## SUNDRY NOTICES AND REPORTS ON WELLS

Bank 13 Federal Com. #1H

OXY USA Inc. – Amend APD

## **SUNDRY CONDITIONS OF APPROVAL – 03/26/2012**

Occidental Permian Ltd.  
Bank 13 Fed #1H  
Eddy Co, NM

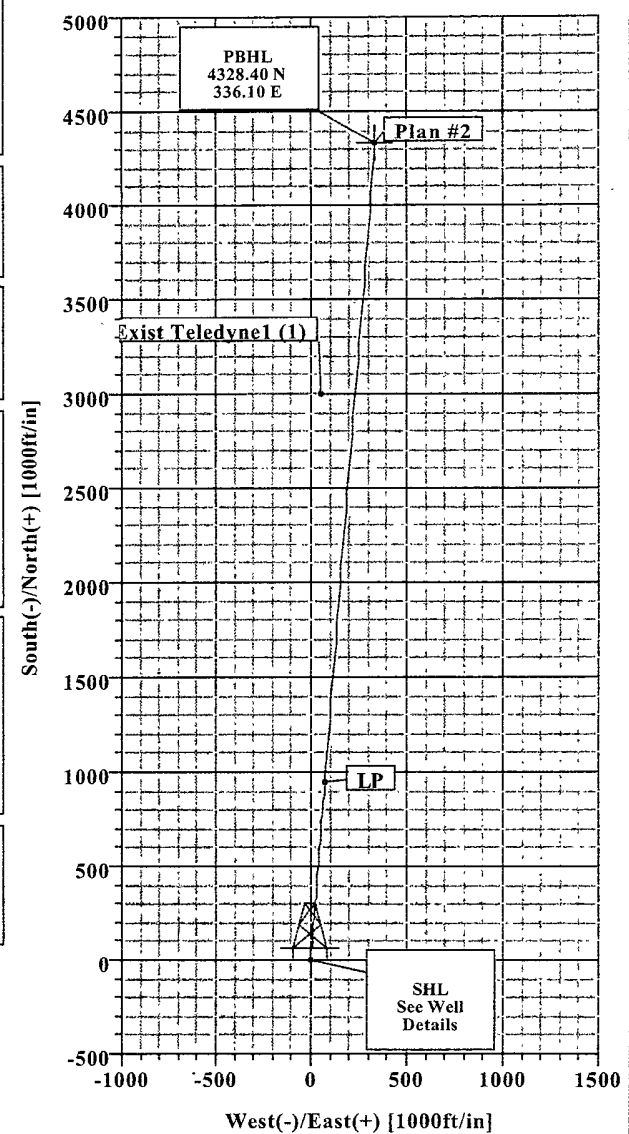
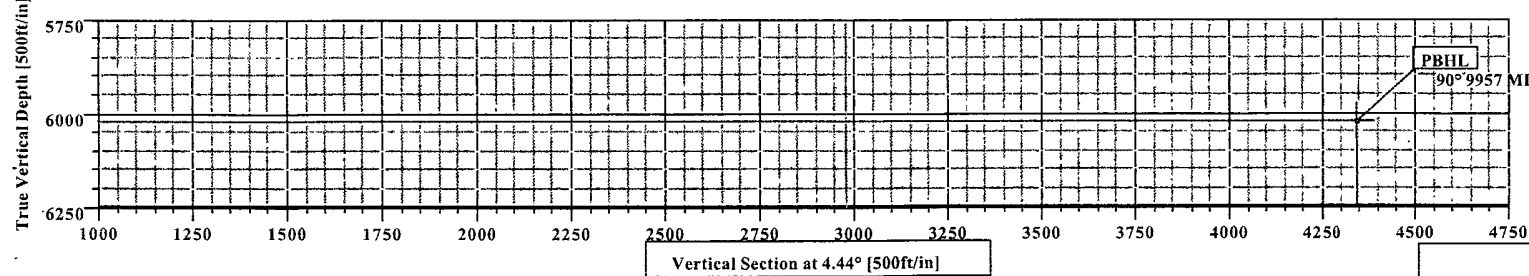
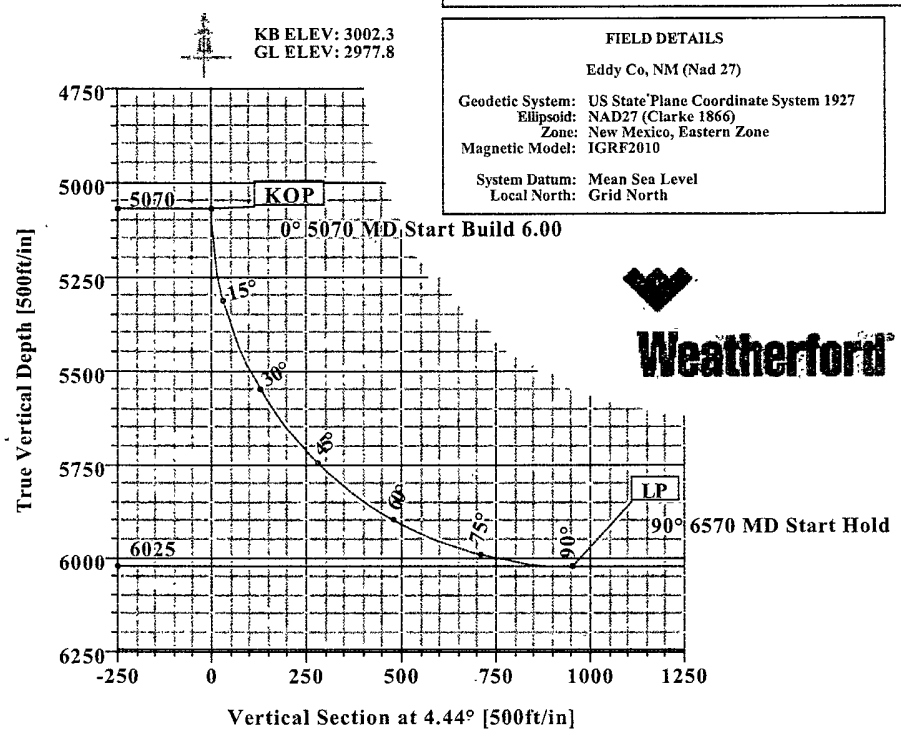
1. Amend the proposed TD's. 6025'-TVD 9987'-TMD
2. See attached for the amended intermediate & production casing programs.
3. See attached for the amended cementing programs.
4. See attached for the amended proposed directional drilling plan.

OXY USA Inc. respectfully requests to amend the approved APD. OXY has received updated formation tops and a different directional plan which decreased our build rate to 6°/100' from 10°/100' and changed our PBHL TVD depth. Because of these changes we have increased the setting depth of the Intermediate casing from 2700' to 2900' and the new PBHL will be 9987' MD / 6025' TVD. The changes in both the Intermediate and Production sections have altered the cement volumes too. Also, due to the shallow Surface casing depth, the surface cement job will be a single stage instead of the typical dual stage.
